**FARRAGUT VISUAL RESOURCES REVIEW BOARD
AGENDA**

Tuesday, May 25, 2021

MEMORANDUM

TO: Farragut Visual Resources Review Board
FROM: Bart Hose, Assist. Community Development Director.
SUBJECT: Regularly Scheduled Meeting - Tuesday, May 25, 2021 at 7:00 p.m.

a) Tennessee Cutlery Tenant Panel Sign – 11414 Kingston Pike

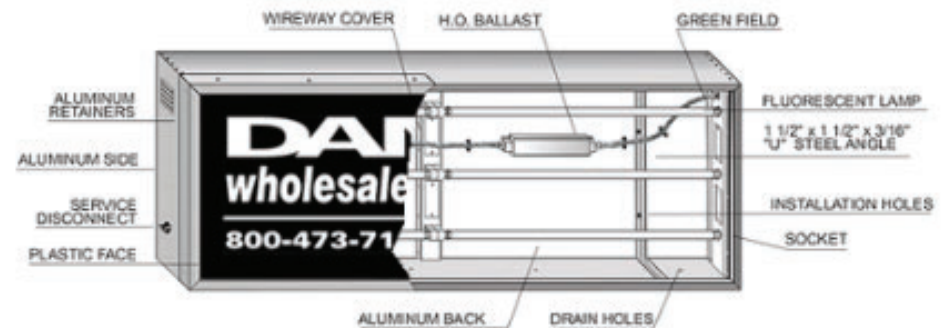
Tennessee Cutlery is requesting approval for a tenant panel sign located at 11414 Kingston Pike. The property in question contains two multi-tenant ground sign structures and this panel is located on the easternmost sign. The panel has already been installed and the applicant will be assessed a second fee for installation without a permit.

The sign panel appears to be legible, and the staff can recommend approval.

b) UBank Ground Sign – 155 North Campbell Station Road

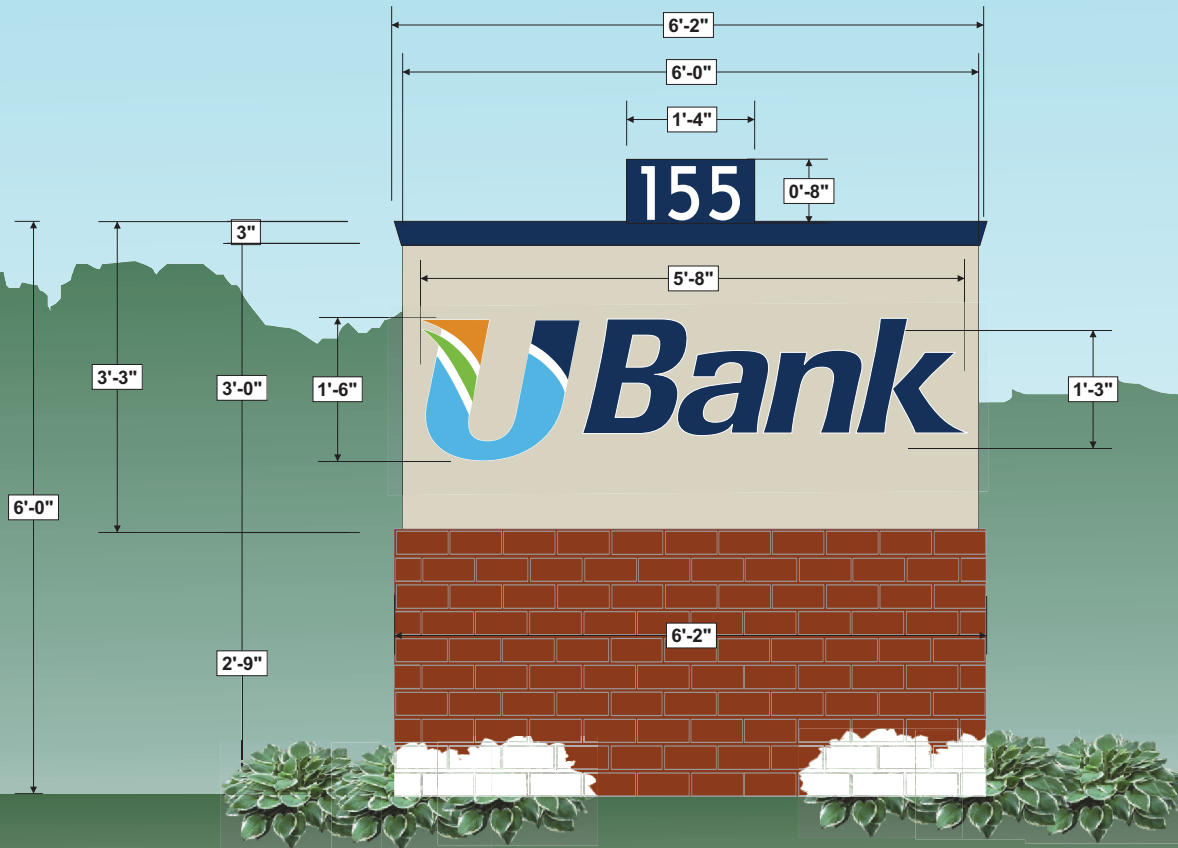
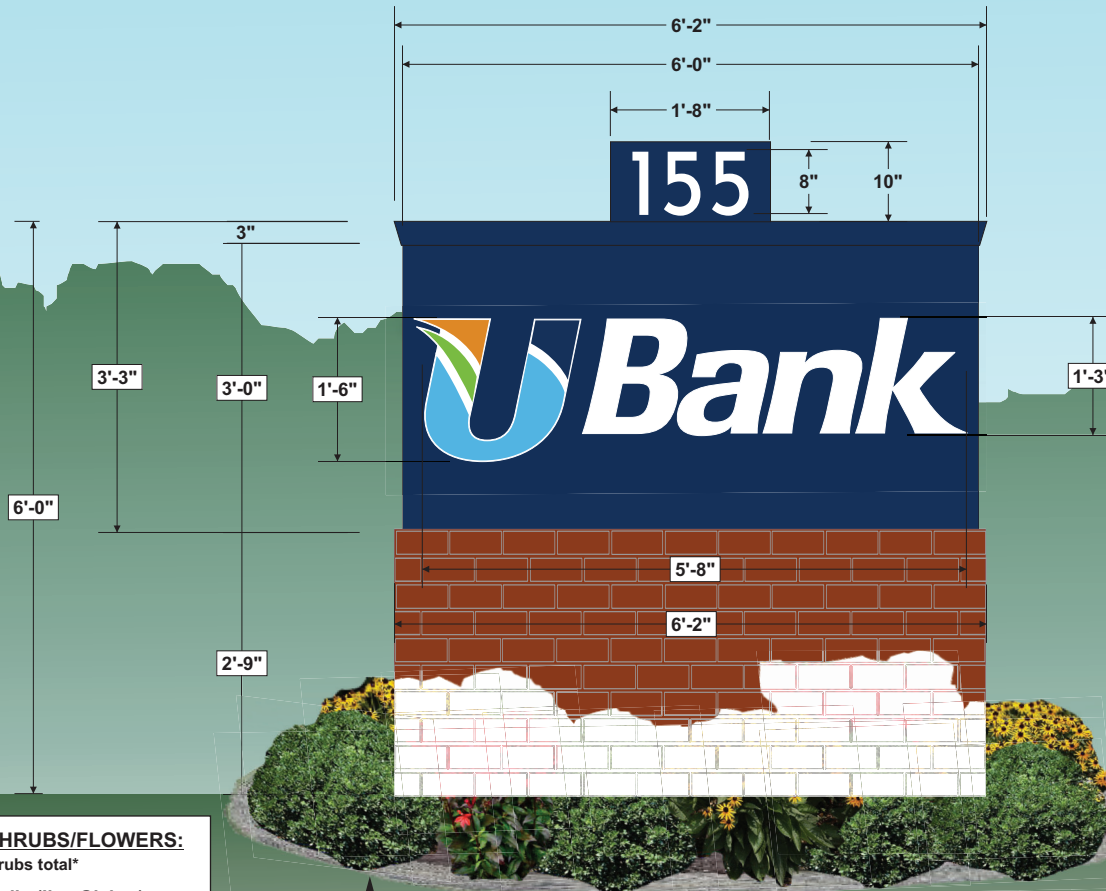
The plan includes a new 18 square foot monument ground sign. The proposed sign and plan include the required minimum (2 foot) base and landscaping. The minimum front setback for a sign of this size is 10 feet from the property line. The applicant has included two color renderings at staff's request. The Town's adopted Architectural Design Guidelines call for the use of dark backgrounds with light colored lettering. The staff has been considering these guidelines, along with other competing compatibility concerns, when reviewing new ground signs.

The staff recommends approval of the version with the darker blue background and white lettering, subject to verification that the landscaping will be located around the sign base in accordance with the standards, and a survey being required to document that the installed sign meets setback and other applicable standards.

c) Blockbuster Property Shopping Center Ground Sign – 11135 Kingston Pike

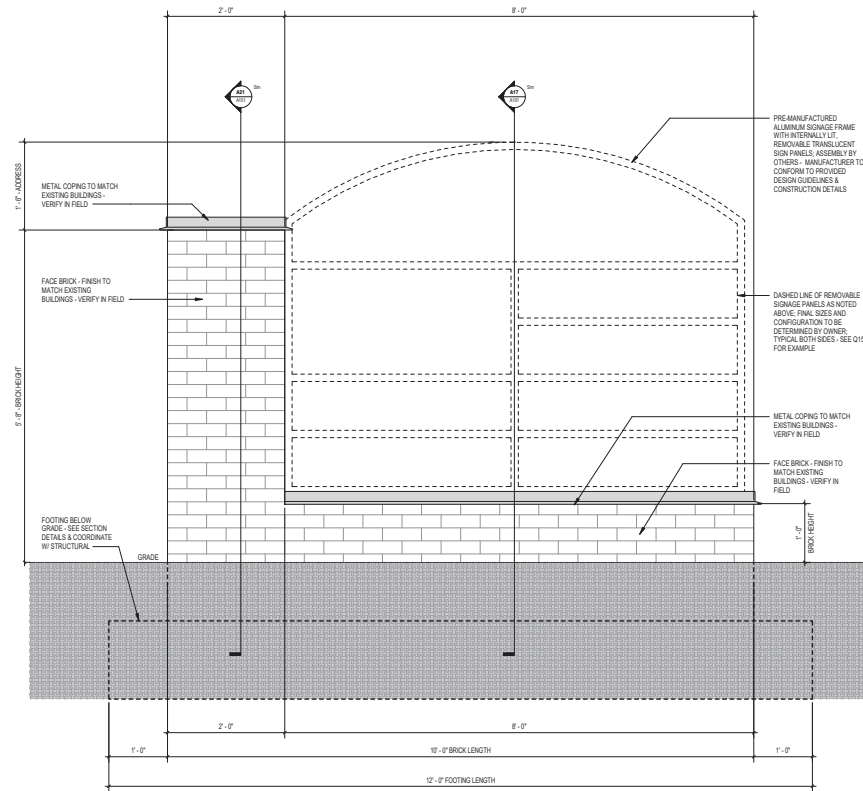
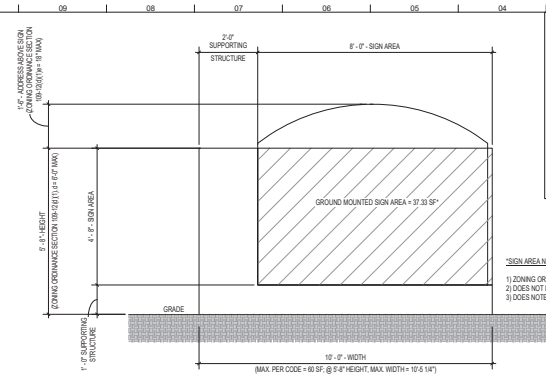
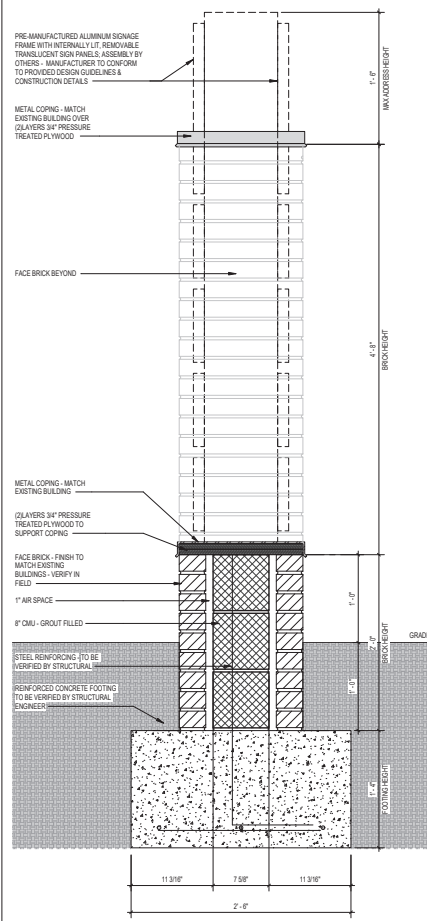
The plan includes a new, approximately 38 square foot multi-tenant monument ground sign. The submitted plans and materials do not meet minimum requirements. No color rendering was submitted. The planned sign does not include the required minimum two-foot-high base. The landscape plan for the larger site does not conform with the previously approved landscape plan and will need to be both coordinated with the sign plan and resubmitted for approval. There is at least one plant substitution being requested by staff around the sign. There is also a small discrepancy between the address area's maximum allowable height on one of the drawings that will need to be corrected and the plan needs to document that the address numbers are a minimum of 8 inches tall. The applicant has been contacted regarding these issues and has yet to address them.

The staff recommends that the request be denied or deferred and tabled until the applicant submits corrected plans for review at a future meeting.
